Herschel SPIRE IID-B updates

Annex to minutes SPIRE-AST-MOM-001244

HP-2-ASTI-1346

Version	To go from 2.1 to 2.2
Date of issue	17/4/2002
Prepared by	John Delderfield
Approved by

HSFPU Isometric Views

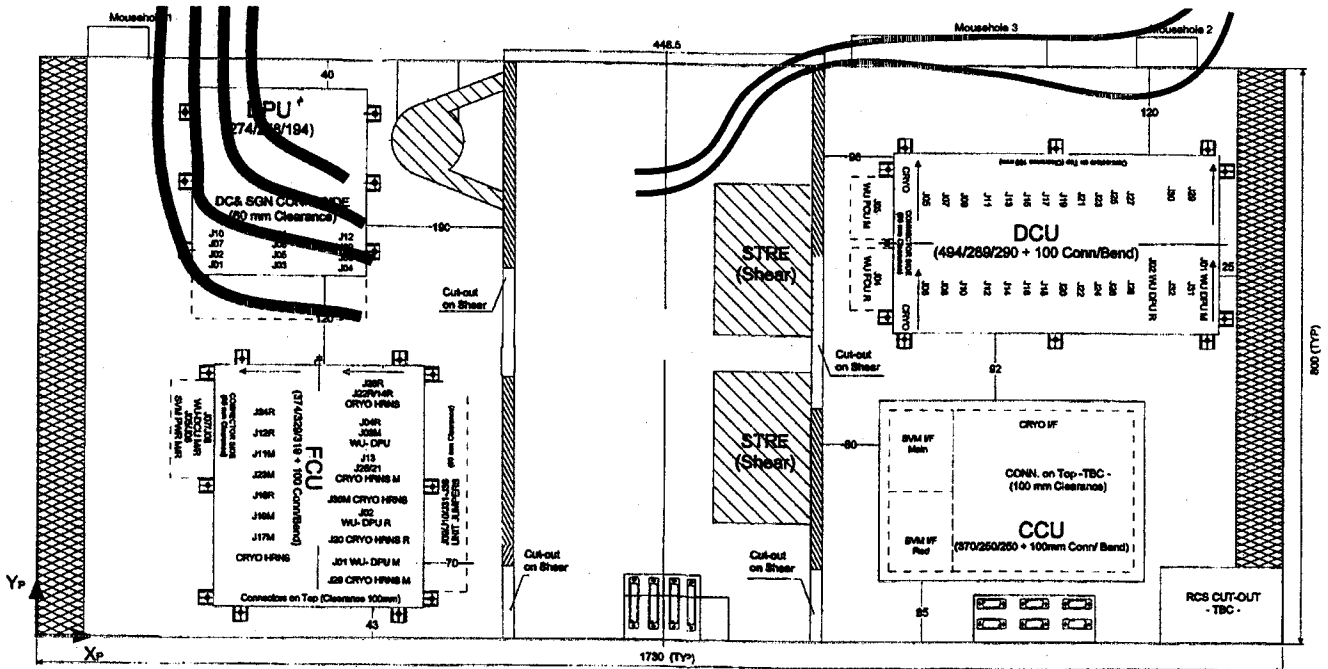
5.3.2	Change (tbd) to 7				
5.4.1	Remove detailed drawing sheets and just put in the two HSFPU isometric views shown below. The detailed ones go in annex.

HR-SP-RAL-ECR-009- v5

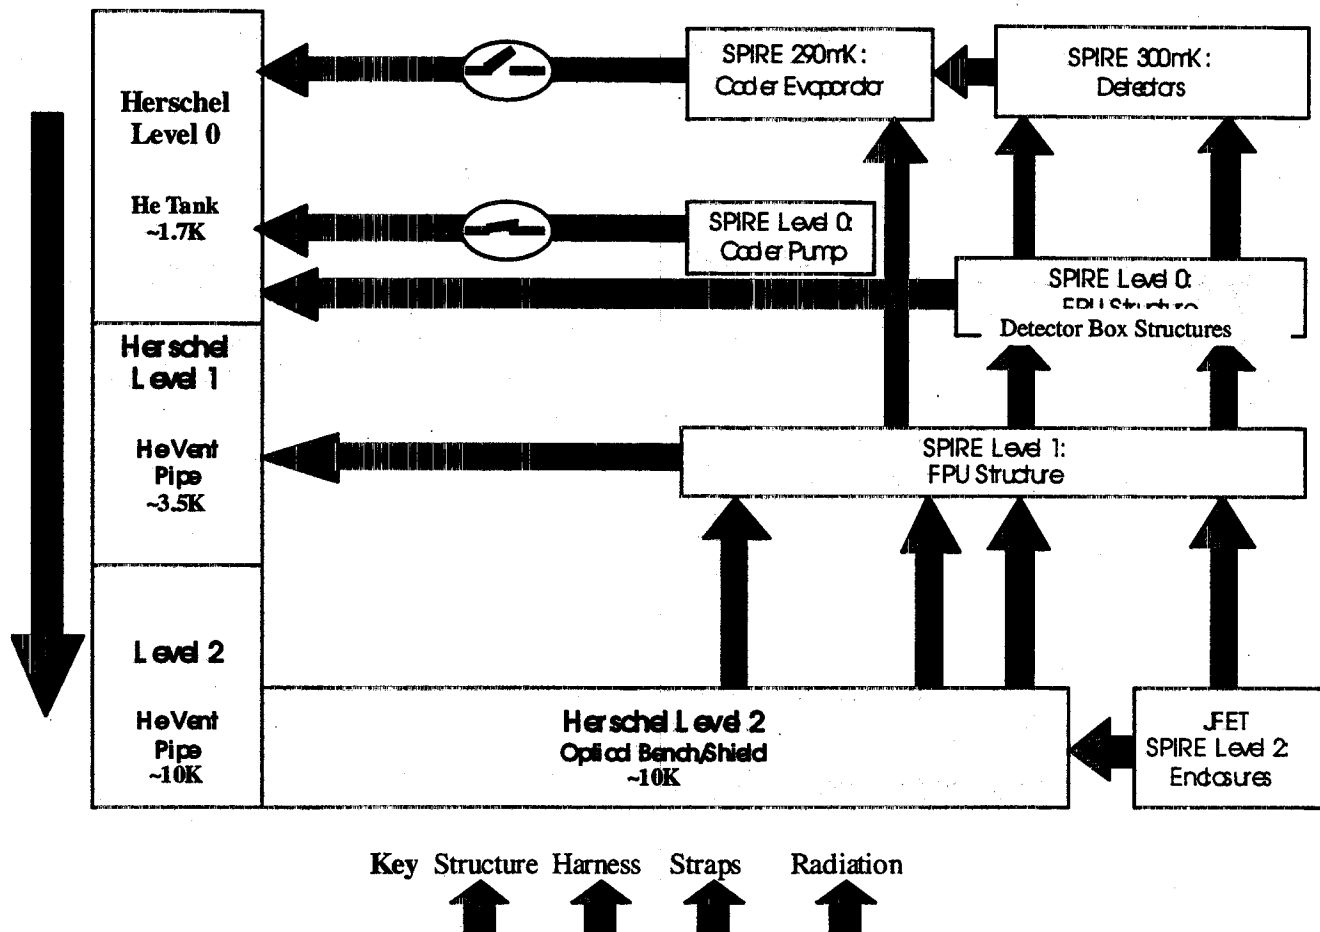
The following paragraphs (5.7.1 to 5.7.1.2) are a statement of the SPIRE requirements on the Herschel system. However, industry can not commit to the requirements below, but is investigating refining its design with these as objectives. A number of technical options have been identified, both on satellite and SPIRE Instrument sides, which need to be analysed to converge to an interface definition. An objective is to meet both the cryostat lifetime and SPIRE thermal requirements. This shall be settled and formalized via the regular Change Request process.

The various instrument stages require straps to 3 different temperature levels. An indicative overview of the heatflows in the system is:

5.7.1.1 Reasons for Spire Level 0 interfaces

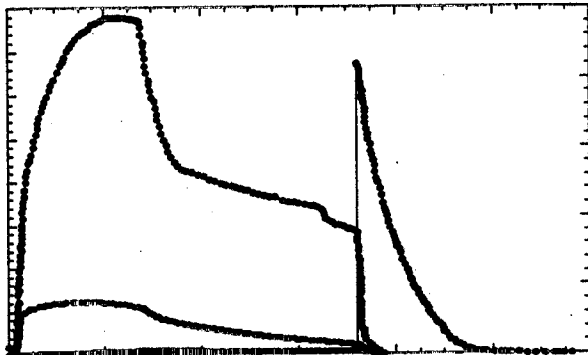
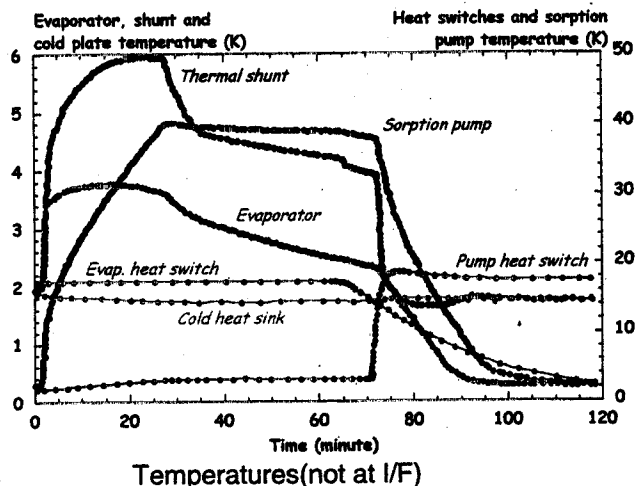
First the sorption pump is heated to ~40K and the evaporator's heatswitch ON to conduct heat to the HPLM Helium II tank, so the ³He condenses back into the cooler's evaporator. A temperature of the evaporator during this phase maximises the recycling efficiency (i.e. ratio of Liquid ³He to condensed ³He), a factor in maximising its subsequent 300mK hold time. The sorption cooler manufacturer stipulates a conductance of >0.1Watts/Kelvin between the HPLM Helium II tank and the sorption cooler evaporator heatswitch I/F.

At the end of the condensation phase of the cooler's regeneration, the heat switch on the sorption pump is turned ON and the switch on the evaporator is turned OFF. There is a substantial (~450mW) peak power from the sorption pump to the cryostat as it is re-cooled. The design of HPLM Helium II cryostat should be such that this peak power and associated energy does not have any significant impact, such as cryogen surface film breakage. During this phase, the evaporator strap shall be below 2K, to avoid re-evaporating the condensed ³He.

These operating modes mean that the Pump Strap and the Evaporator straps must be sufficiently insulated from each other. There are thus two straps from the cooler, one for the sorption pump and one for the evaporator. In this way, during normal operation, the temperature of the evaporator strap will remain at T_{bath}+DeltaT (as small as possible), leading to a good condensation efficiency and less ³He lost during the cooldown from 1.7 K to 0.3K.
